FREDERICK COUNTY PLANNING COMMISSION

TITLE: Alban Cat

FILE NUMBER: SP-05-07 AP #16668 (APFO#16669, FRO #16670)

REQUEST: Site Development Plan Approval

Graphic #2: Alban Cat Zoning Map

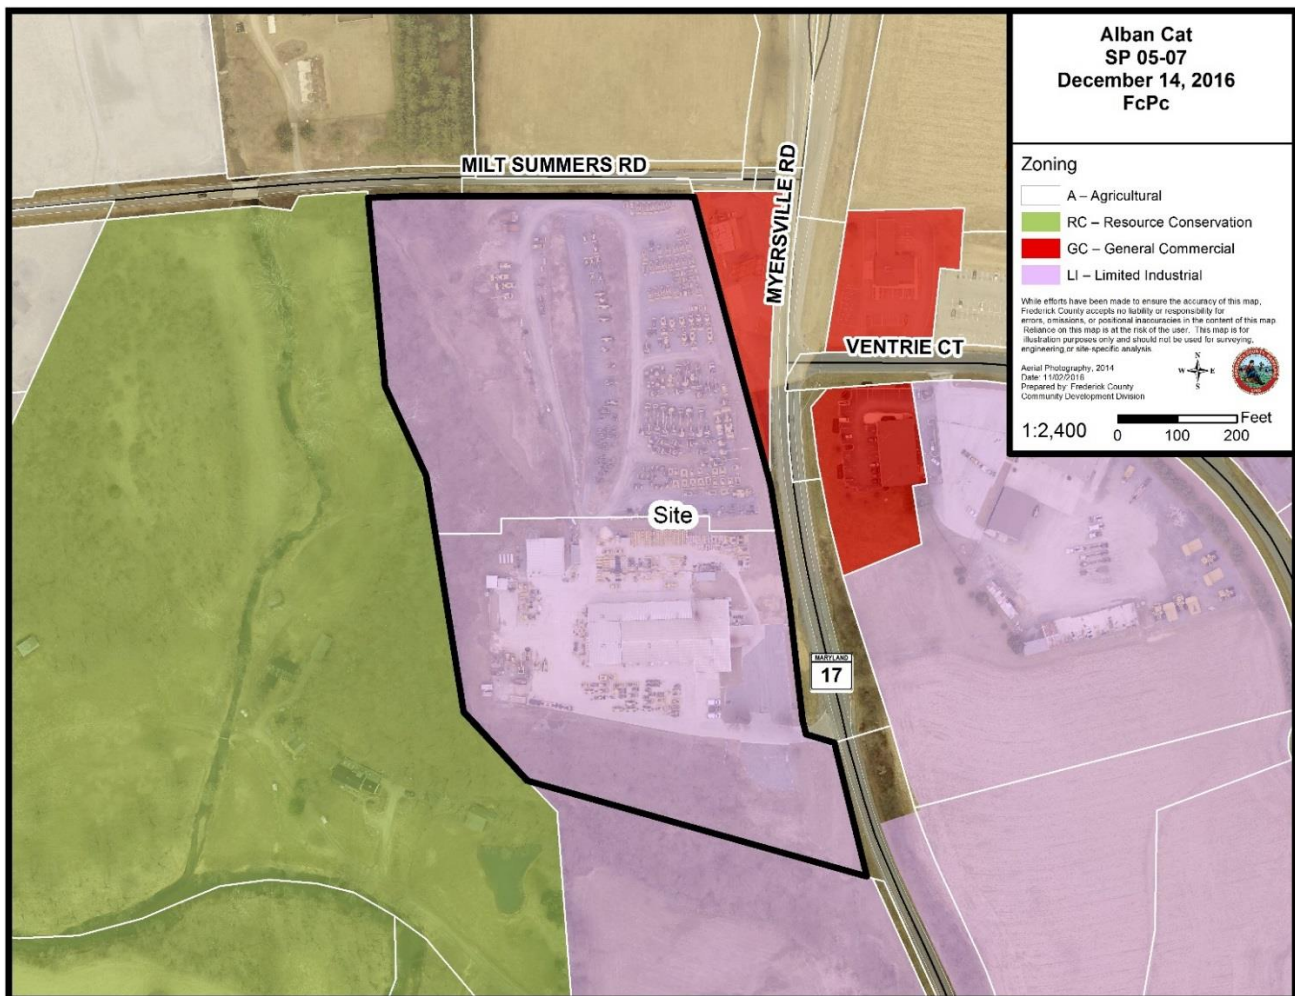
The site is currently zoned Light Industrial, and is developed with an existing Heavy Equipment Related Services facility. The properties to the west and south are undeveloped Resource Conservation and Agriculture zoned lands. The municipal boundary of the Town of Myersville is located to the north and northeast of the subject property. There is also a small General Commercial (GC) zoned property immediately to the east of the subject site that is developed with a Gas Station (see Graphic #2). The plan was submitted to the Town of Myersville for review and comment. The Town reviewed the plan and no comments relevant to the site development plan review criteria were provided.

Exhibit 1-Alban Cat: Site Plan Rendering

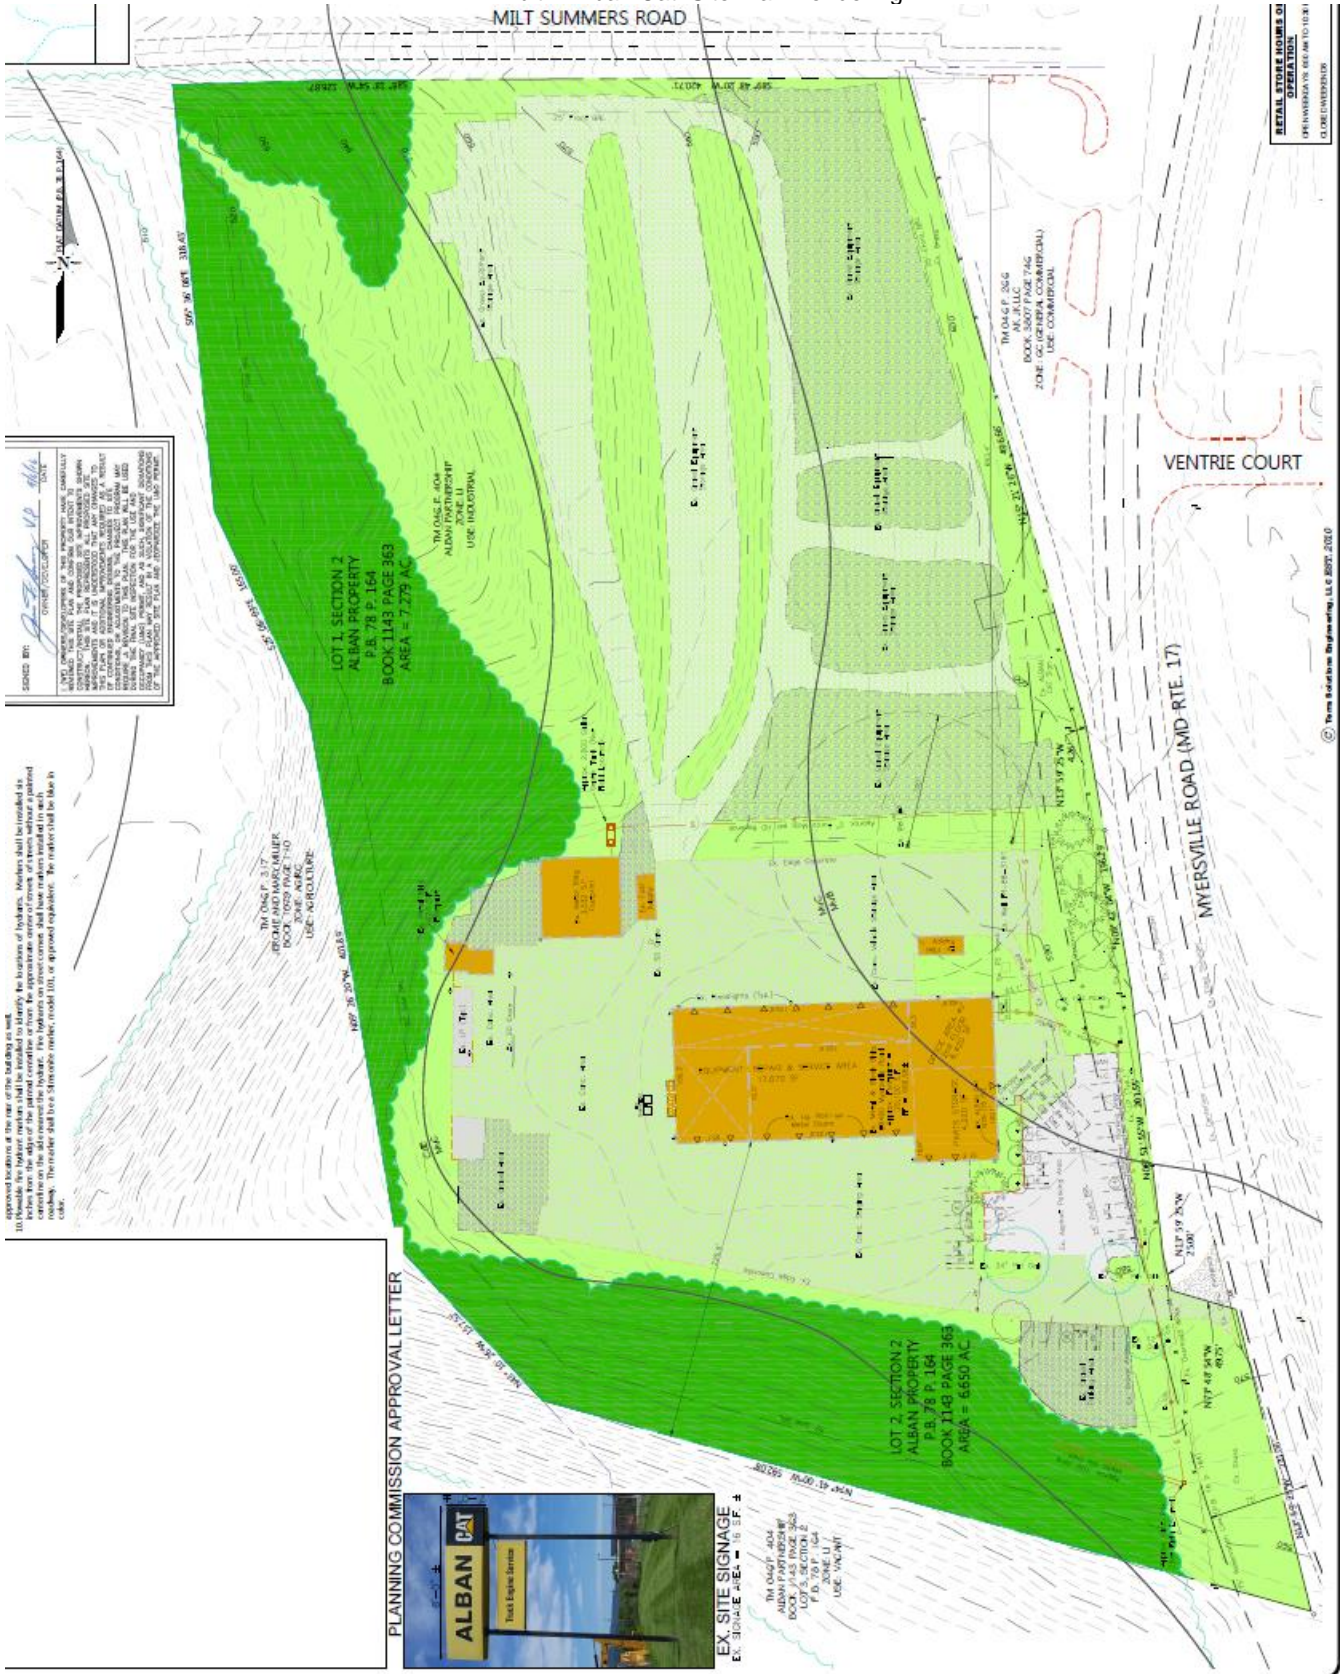
In accordance with §1-19-6.400.A.1, the Applicant is required to provide 35 street trees along the frontages of Myersville Road and Milt Summers Road, 19 and 16 respectively. Two Pin Oaks, and two Red Maples are proposed along Myersville Road, south of the existing sign. This proposed landscaping will assist in screening the existing service bays and the main vehicle storage area located to the north of the principal structure. The remaining two Red Maples, two Pin Oaks, and three Dogwoods are all proposed to be planted around the main parking area in order to provide additional canopy cover and increased site aesthetics.

In accordance with §1-19-6.400.D.2; a minimum of 20% canopy is required over the proposed parking areas. The Applicant is required to provide 2,330 square feet of canopy coverage over the existing parking spaces. The total proposed landscaped canopy coverage of the site will be 1,700 square feet or approximately 14.6%.

In accordance with §1-19-6.400.I, the Applicant has requested a landscape plan modification due to planting conflicts within the existing parking area, see Exhibit #3. Staff worked with the Applicant in order to develop a landscape plan that accommodated the existing facility and site function, while increasing the amount of overall landscaping on site.

Based on these calculations, the Applicant is required to provide 117 parking spaces and the Applicant has 38 existing parking spaces on-site, including two (2) ADA accessible spaces. In accordance with Z.O. § 1-19-6.220.A.1, the Applicant is seeking a parking space modification in order to permit a reduction in the overall parking on site. The existing site plan (SP-05-07) approved in 2005, reflects the existing operation on Lot 2 and utilizes the generic industrial parking calculation

Existing Parking Stall Dimensions: There is no construction, expansion or further heavy equipment storage proposed as part of this site plan. The site has previously constructed and striped parking stalls with a dimension of 10'x20', which is a deviation from the standard stall size of 9'x18'. In accordance with Z.O. § 1-19-6.220.B.2.a, the Applicant is seeking a parking stall dimension modification in order to permit a 10'x20' parking stall, see Exhibit #2. The majority of vehicles accessing the site are large trucks, where a larger stall dimension is beneficial. Staff has no objection to granting this parking stall dimension modification.

Existing Drive Aisle Dimension: The site contains existing parking aisle dimensions of 38' for the two way drive aisle within the main parking area located to the east of the main Alban Cat sales and service center. The existing 38' foot wide drive aisle is a deviation from the standard 24' two-way wide drive aisle. The facility's existing loading docks are located to the north end of the parking lot, therefore the 38' wide drive aisle is essential for the operations of the business and essential loading and unloading of equipment and machinery parts. In accordance with Z.O. § 1-19-6.220.B.2.a, the Applicant is seeking a drive aisle dimension modification in order to permit a 38' two-way drive aisle, see Exhibit #2. Staff has no objection to granting this drive aisle dimension modification based on existing conditions.

1. Address all agency comments as the plan proceeds through to completion.
2. Prior to final signature approval of the Alban Cat site development plan, Addition Plat (AP 16983) Alban Partnership Addition to Alban Partnership shall be recorded combining Lots 1 and 2, Section 2 into one 13.9 acre parcel. The new liber folio must be listed within Site Plan Note #1, once it is recorded.
3. The proposed uses shall comply with applicable supplementary Industrial district regulations as well as the Industrial District Performance Standards provided in § [1-19-7.600](#) and § [1-19-7.610](#), respectively.
4. Planning Commission approval of the requested parking stall size modification to permit 10'x20' parking spaces instead of the standard 9'x18'.

5. Planning Commission approval of the requested parking aisle width modification to permit 38' wide drive aisles instead of the standard 24'.
6. Planning Commission approval of the requested parking space modification to permit a 79 space reduction in the number of required parking spaces, from the required 117 to the existing 38 spaces on site.
7. Planning Commission approval of the proposed alternate landscaping plan to allow a reduction in street trees from the required 35 trees to the proposed 10 trees, and allow a reduction in canopy coverage from the required 20% to the proposed 14.6% commensurate with the existing facility and site where no improvements, alterations, or expansions are proposed.
